**DESIGN REPORT**  
*FOR*  
**BURKE CREEK HIGHWAY 50 CROSSING AND  
REALIGNMENT PROJECT, PHASE I**  
*STATELINE, NEVADA*

**May 2016**

Comments on Burke Creek HWY 50 Crossing and Realignment Project				
			Commenter: Erik Nilssen P.E., Douglas County	Responder: NTCD Engineering
Comment #	Document	Page	Comment	Response
DC-1	90% Plans	G-1	I am hesitant to use the Bluth property as staging. Mr. Van Bieskirk has threatened an injunction on the project. I would show the Douglas County parking area as staging and put in the specifications under "staging" that additional staging locations will be the responsibility of the contractor.	The 100% Plans have been changed to show the Apartment 801 LLC property as access only. Additionally, text has been added to the special provisions to require owner's permission for storage and staging.
DC-2	90% Plans	G-2	Leader lines for details 4/D-7 and 1/D-1 and 5/D-2 are pointing to the incorrect location	Details have been revised for 100%
DC-3	90% Plans	G-3	The abandonment of the existing stormdrain should go back to the existing catchbasin in the driveway. If we do not wish to remove the CMP, it should be filled with concrete to the catchbasin	Plans a

SHEET  
**CS-5**  
10 OF 19

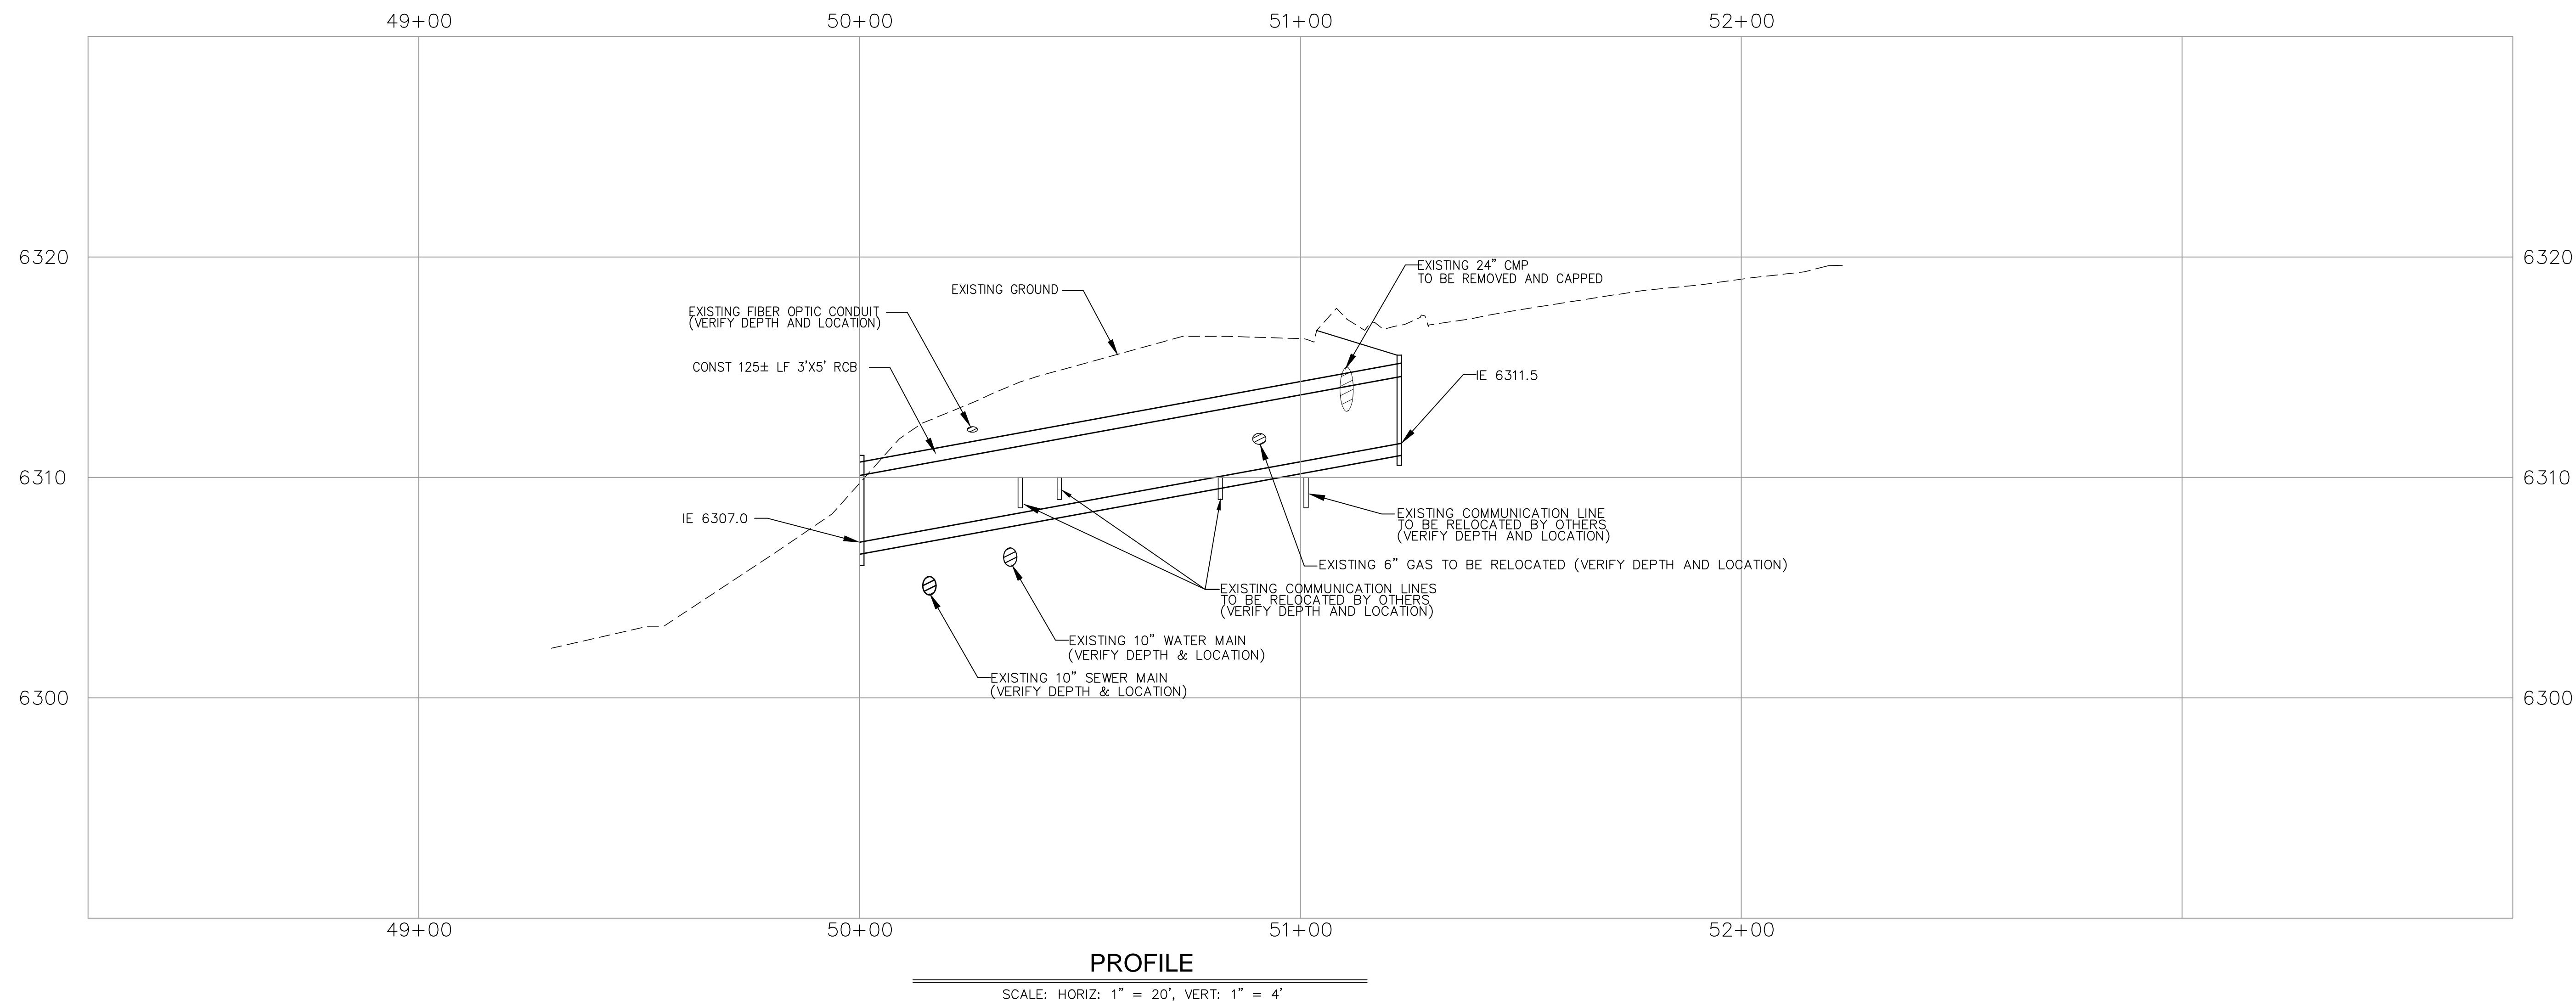
DC-11	90% Plans	C-5	As the scale on these cross sections is large, I believe the invert elevations of the channel's should be called out and the top of berm elevations should be called out.	The channel inverts are shown on the profile, sheet C-3. The berm will be staked in the field.
DC-12	90% Plans	C-7	Provide Stationing for the water line valves	Valves will likely need to be field fit based on the verified location of the existing waterline. Approximate stationing has been added to the 100% Plans

CS-6  
11 OF 19

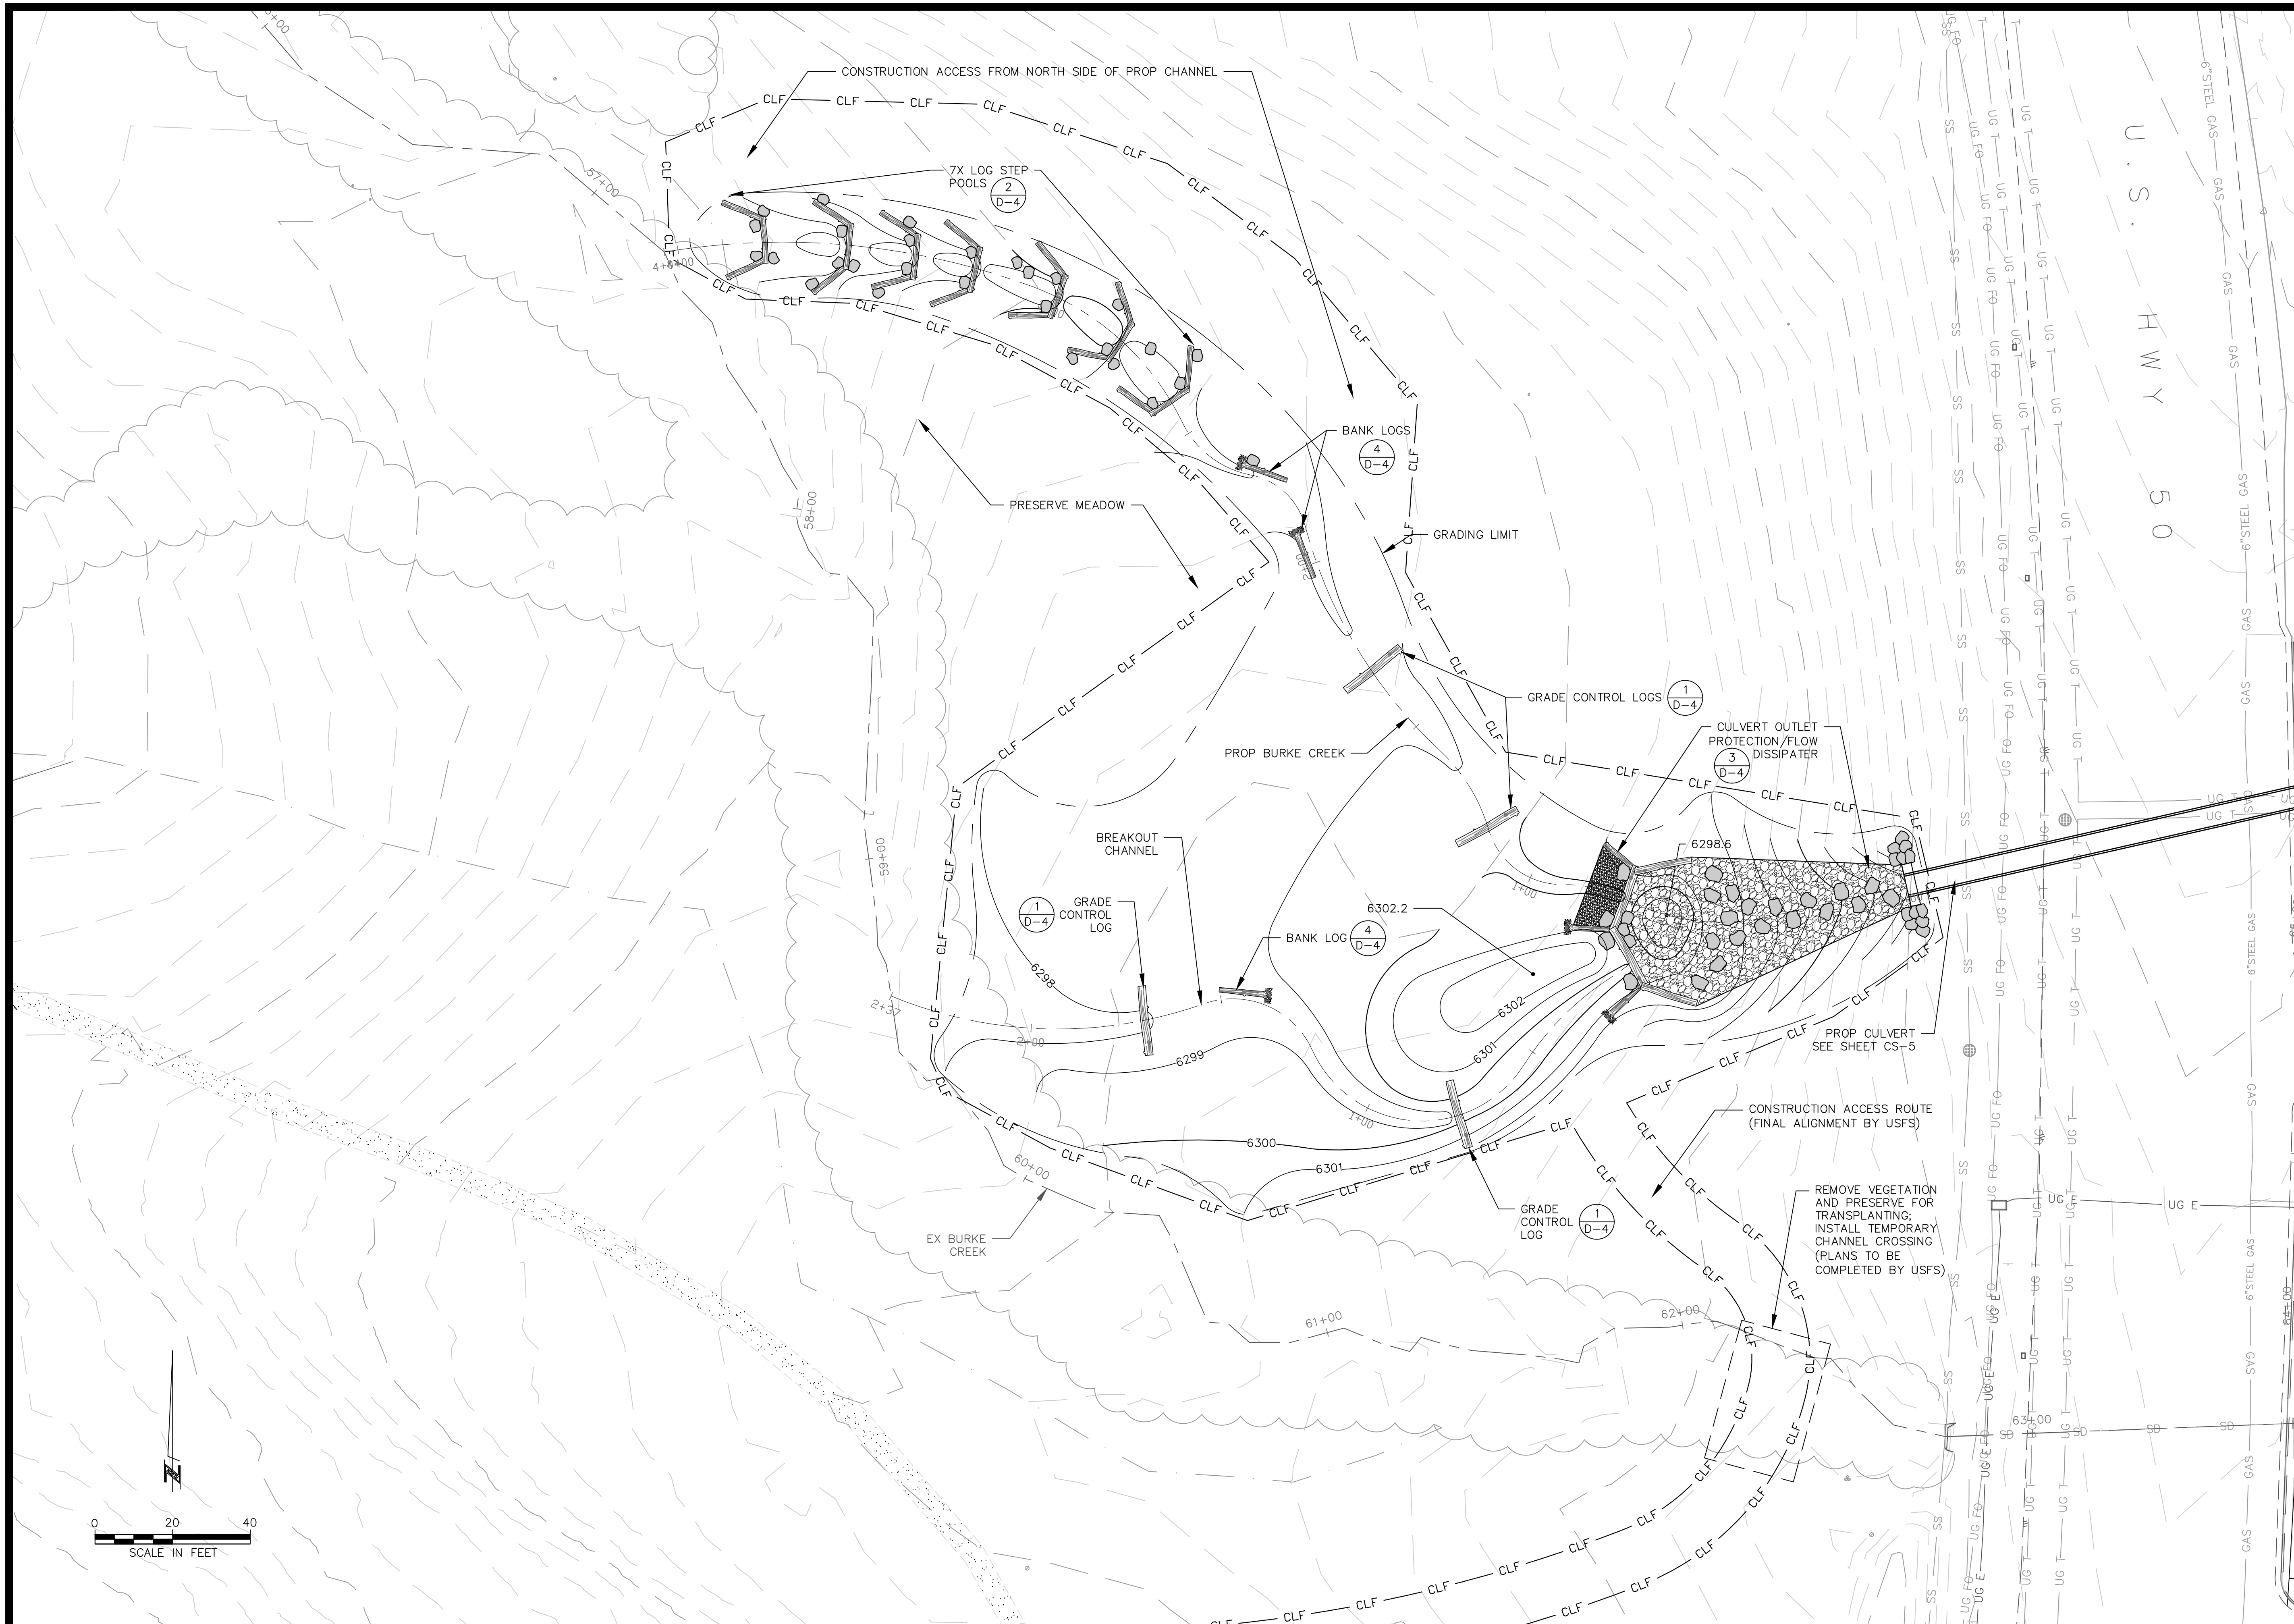
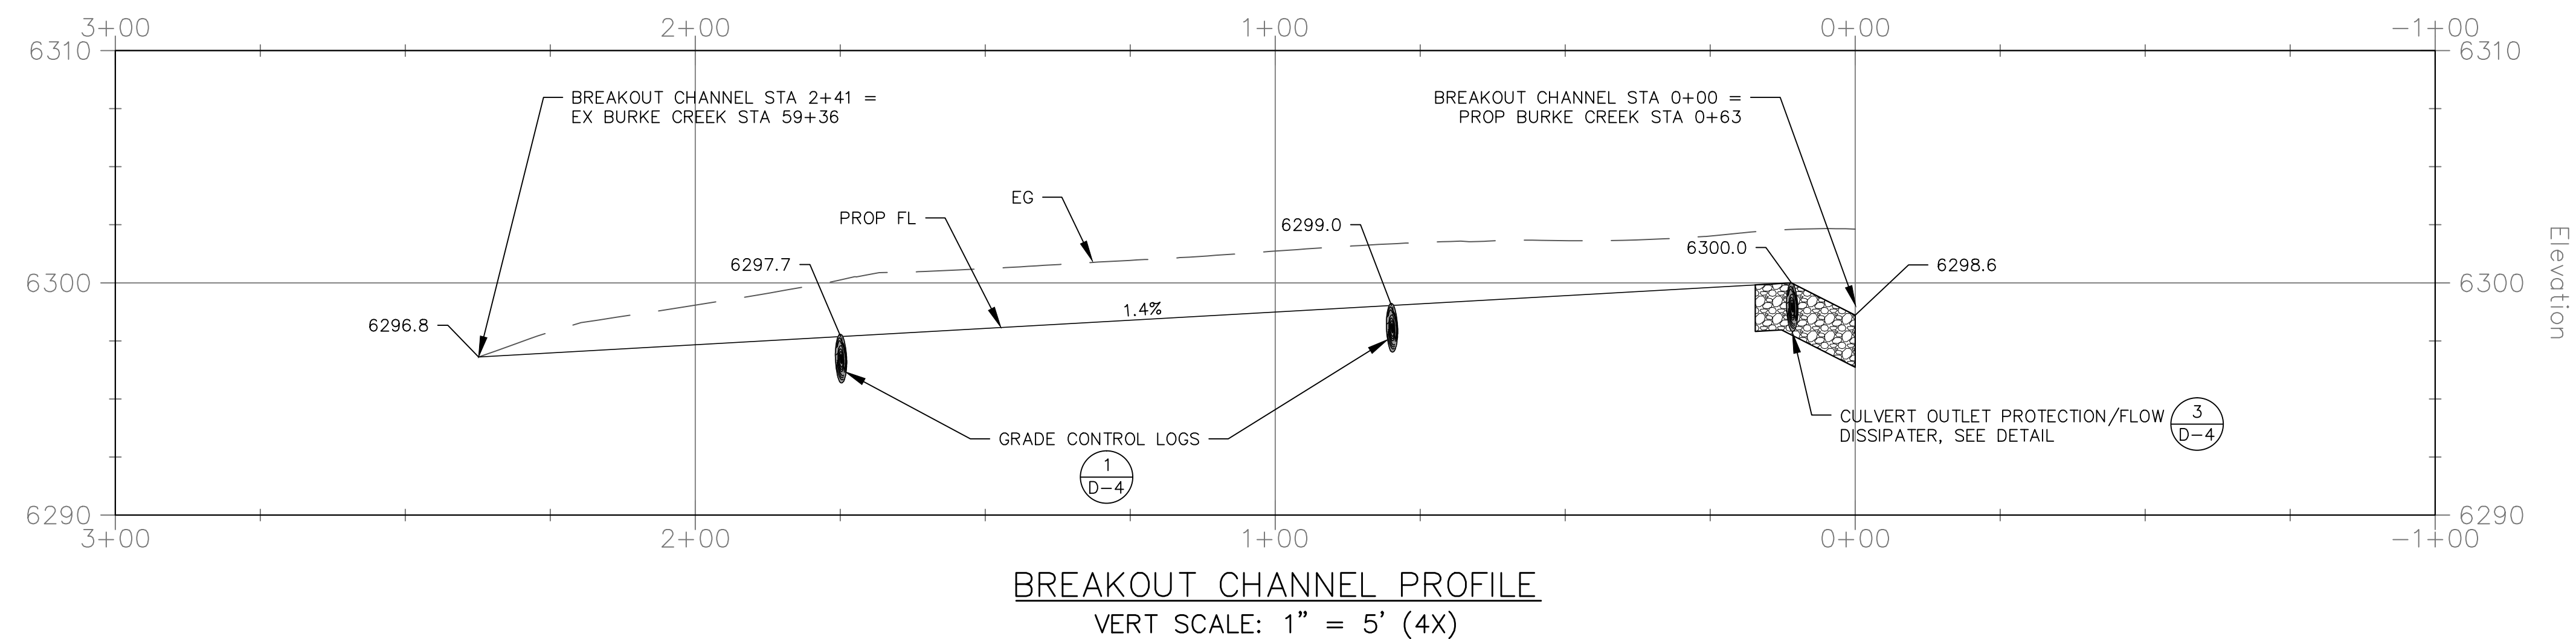
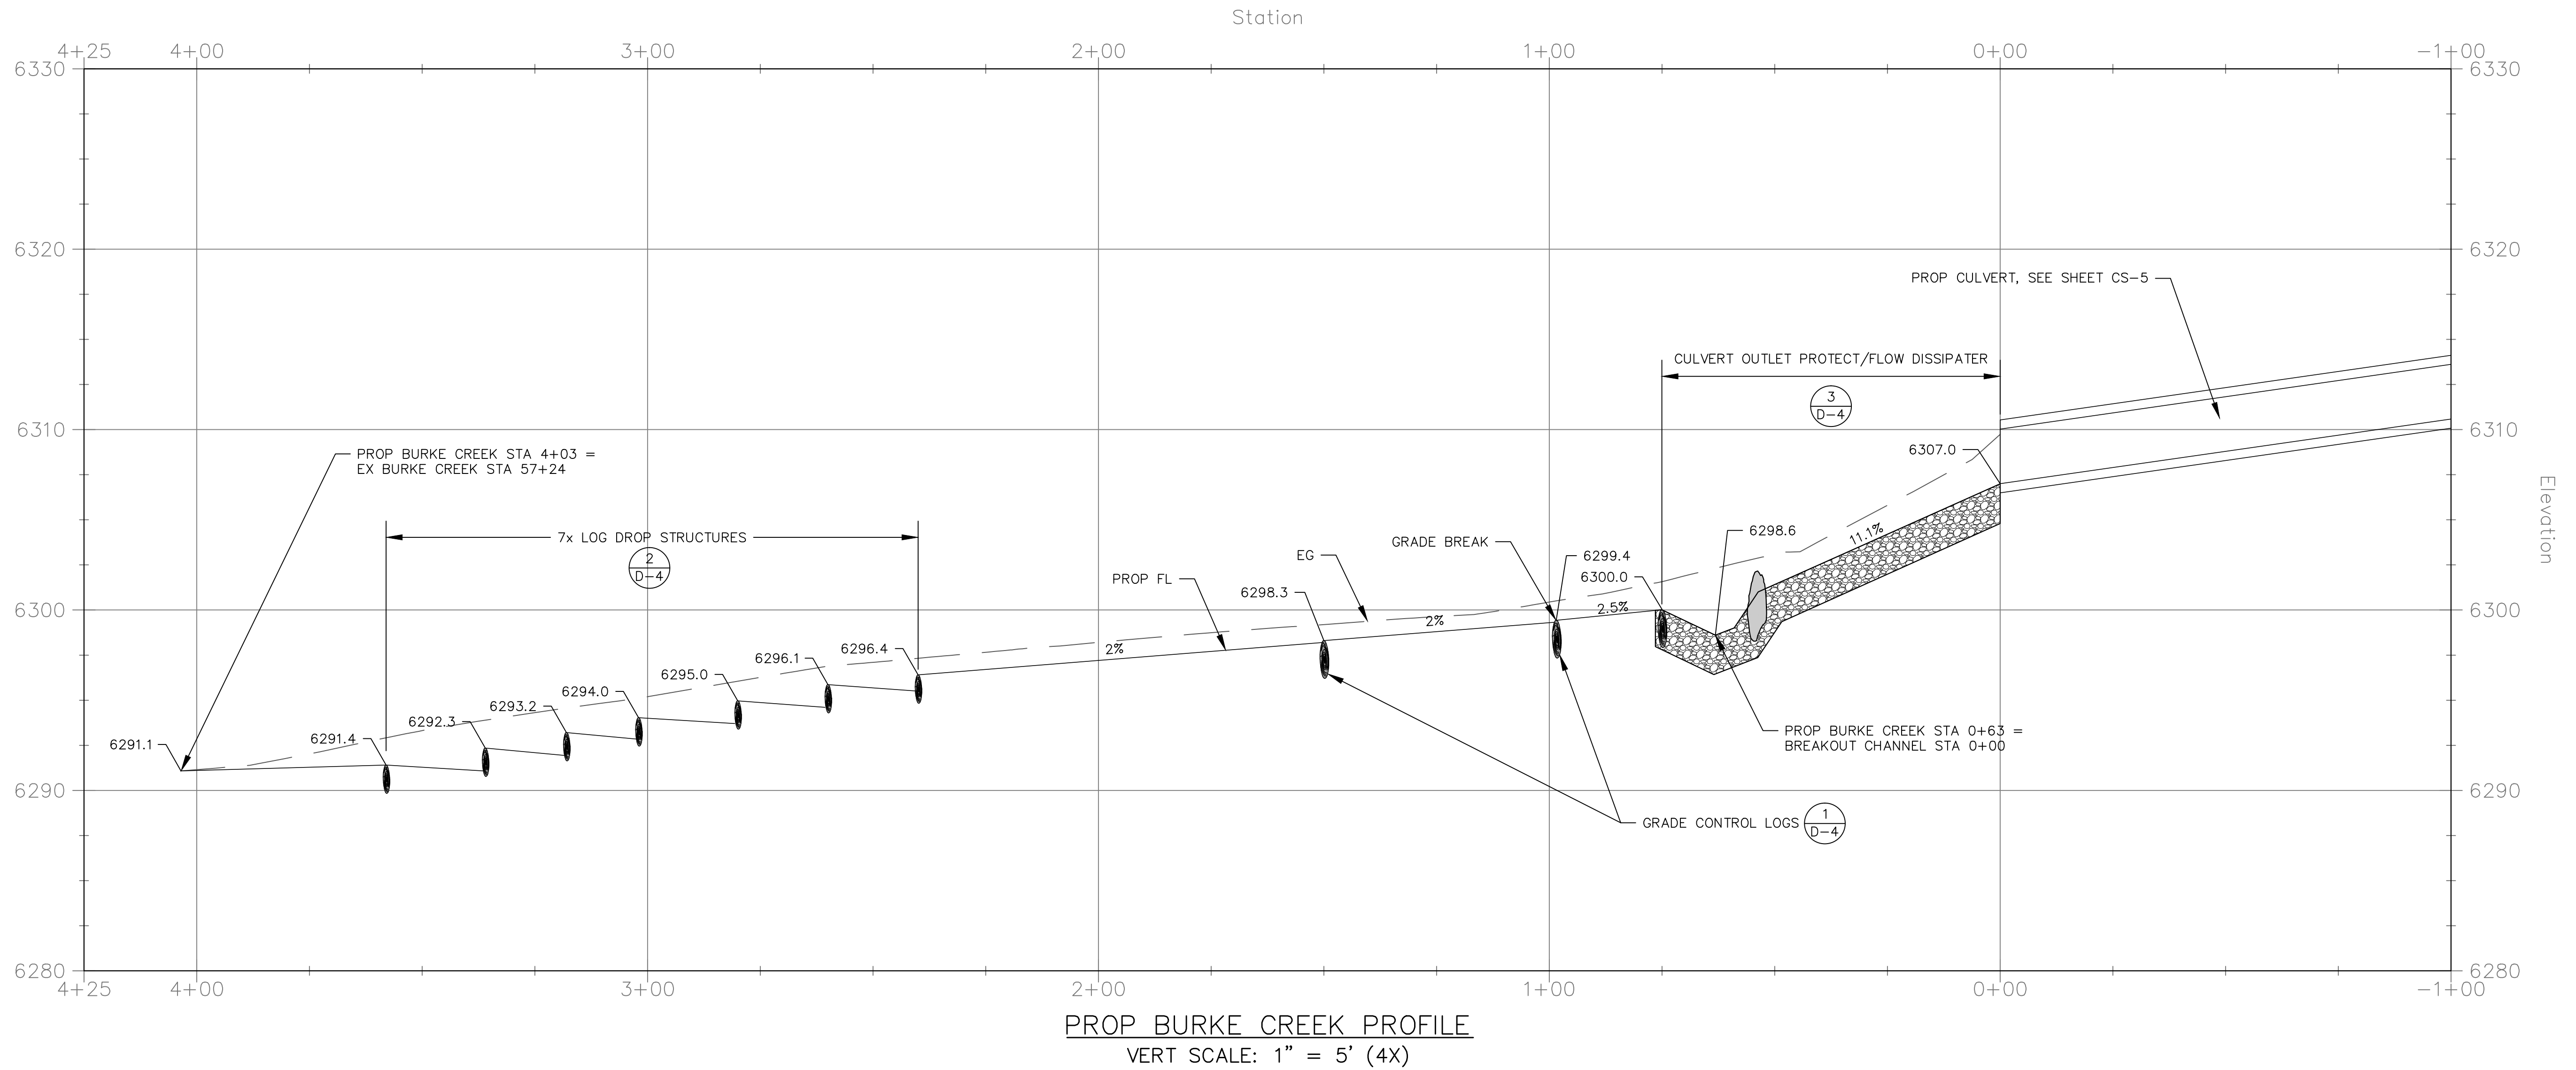
Comments on Burke Creek HWY 50 Crossing and Realignment Project				
			Commenter: Matt Nussbaumer, NDOT	Responder: NTCD Engineering
Comment #	Document	Page	Comment	Response
NDOT-1	90% Plans	C-6, #1	Remove CMP or fill with slurry to the existing DI	Design has been revised for 100%
NDOT-2	90% Plans	C-6, #2	Show existing edges of pavement	Note added to profile for 100%
NDOT-3	90% Plans	C-6, #3	Protection as proposed potentially creates a point load on the CMAP potentially resulting in damage. Please provide additional detailing showing adequate clearance between the SS protection and the CMAP	Detail 3/D-5 shows 3" deep 3/4" minus gravel between slurry and culvert. Detail has been added to the profile for clarity for 100%
NDOT-4	90% Plans	C-7	Remove reference to water tight joints. Not an option with CMP	Reference removed and CCIP liner removed for 100% design.
NDOT-5	90% Plans	C-8, #1-4, 8-9	What are these widths/dimensions? A table might be beneficial.	Notes have been added to clarify dimensions and quantities for 100%. Limits of channel bed material will be staked in the field by the Engineer
